Date: 8/6/2019
To: Potential Bidders
SUBJECT: 17th Street Bridge Replacement over Union Pacific Railroad
Bid Addendum #2
Trenton, MO, Grundy County
Job No. RRP-000S(416)

Bid Addendum #2
Bid Form
&
Q/A regarding Barrier/Moment Slab Construction

- Bid Form

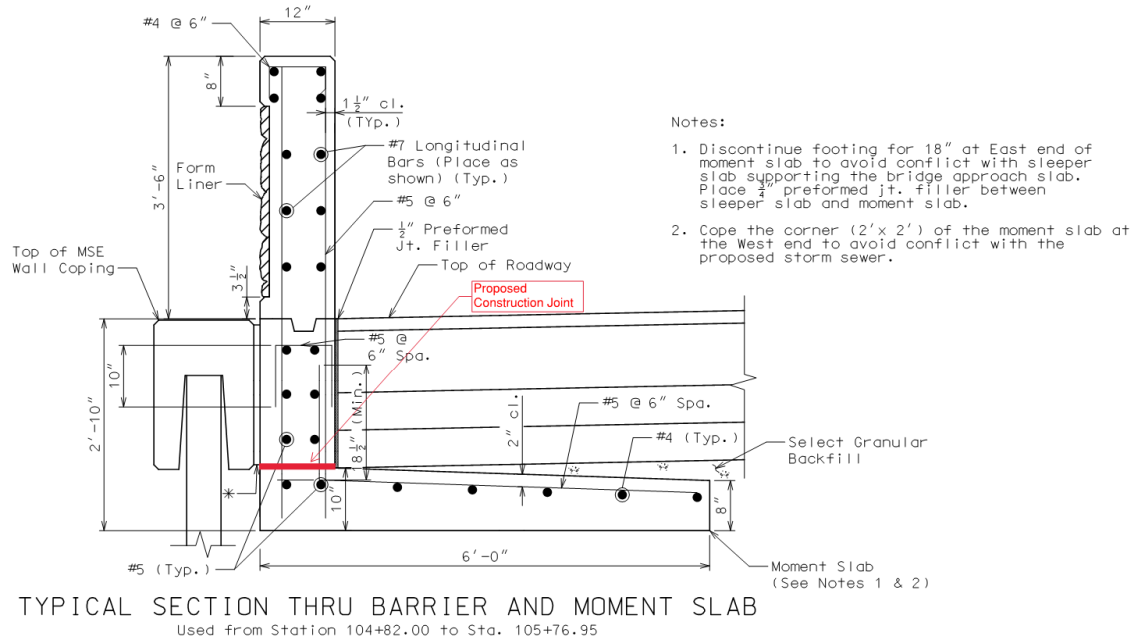
Revised the unit of measure to be square yards for item #65, Slab on Concrete Beam.

This was correctly shown on the bridge plans but was mistakenly labelled as lineal feet on the bid form.

Replace page 13 of the Project Manual with the attached page.
